Subject: **April 2012 Compliance Evaluation Inspection**

**CWA COMPLIANCE EVALUATION INSPECTION REPORT  
U.S. ENVIRONMENTAL PROTECTION AGENCY, REGION 5**

L'Anse Warden Electric Company  
Fuel Aggregation Facility  
17696 U.S. Highway 41  
L'Anse, Michigan 49946  
46.749590, -88.462230

Photo IMGP9097: Dumpsters used to remove the scrap railroad tie and dirt material.  
Direction: Facing northeast.

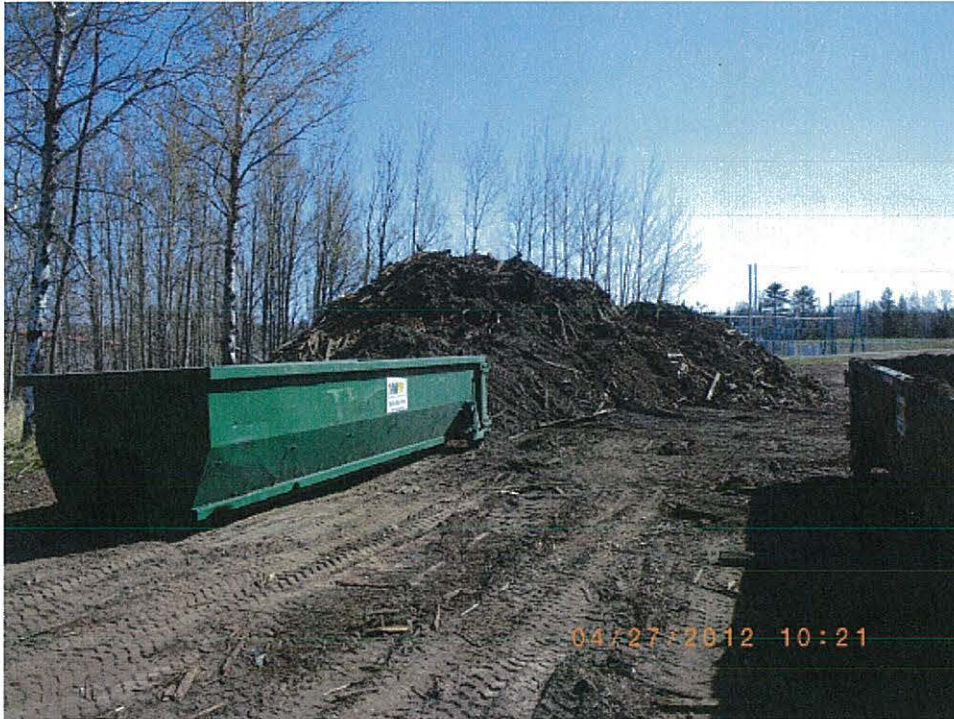
I observed a pile of railroad tie scrap wood pieces and dirt at the northeast corner of the facility where railroad ties are unloaded from the railcars (Photo IMGP9098). Facility representatives identified the pile as material removed from the bottom of railcar after railroad ties have been offloaded. Next to the pile were two uncovered dumpsters (Photo IMGP9097). Railroad tie pieces and soil are loaded into the dumpsters and shipped off site. The current pile was too large to be put into two dumpsters. Facility representatives stated that dumpsters are not picked up frequently enough to only store the material in the two dumpsters. I observed that there was silt fencing along the north side of the pile (Photo IMGP9098). Any runoff from the pile that would leave the FAF would flow through a heavily vegetated wooded area before reaching CertainTeed (Photo IMGP9098). The silt fencing was the only structural control identified.

Photo IMG9058: Wood fines accumulated under the conveyor leading to the wood room building.  
Direction: Facing northwest.

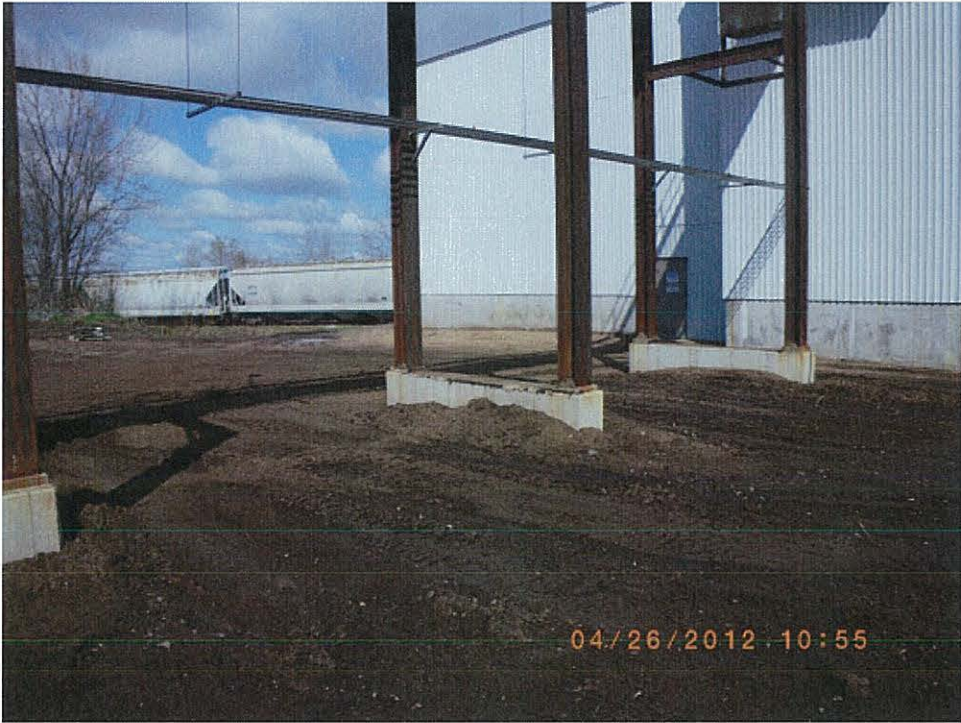
I observed that the conveyor belt to the wood room building is covered, but there was a buildup of fine wood particles underneath the conveyor (Photo IMGP9058). I observed fine wood particles falling from the conveyor. The area below the conveyor was wet. There was a section of silt fencing that remained from previous construction activity that was located next to the conveyor loading bin. There were no other structural controls observed around the wood room building or under the conveyor. I observed a ditch that entered the woods near the the northwest corner of the wood room building (Photo IMGP9094). The ditch was vegetated once it entered the woods (Photo IMGP9095). The ditch led to the stream along the west side of the FAF (Photo IMGP9096). No flow was observed in the ditch during the inspection.

Photo IMGP9093: Runoff pathway along the south side of the railroad tracks leading to the ditch at the northwest corner of the wood room building.  
Direction: Facing west.

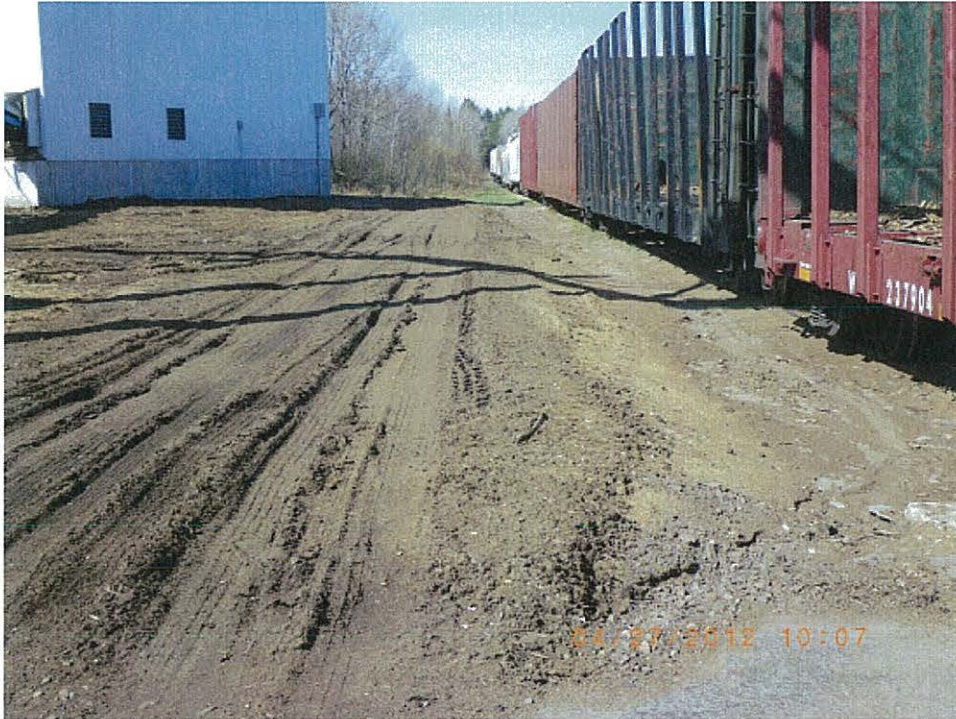
I observed a runoff pathway along the south edge of the railroad tracks that entered the ditch at the northwest corner of the wood room building. A facility representative identified the sources of storm water that contributed to the pathway as the runoff from the central dirt area in the FAF and from a Verso wood storage area culvert (Photo IMG9092). I observed that the re-chipping pile was upslope of the runoff pathway. The pathway was well defined until it entered the woods at which time it became vegetated (Photo IMG9094, IMG9095, IMG9096 and IMG9093). The ditch connected with the stream that runs along the west side of the FAF. There were no structural controls around the pathway at the time of the inspection.
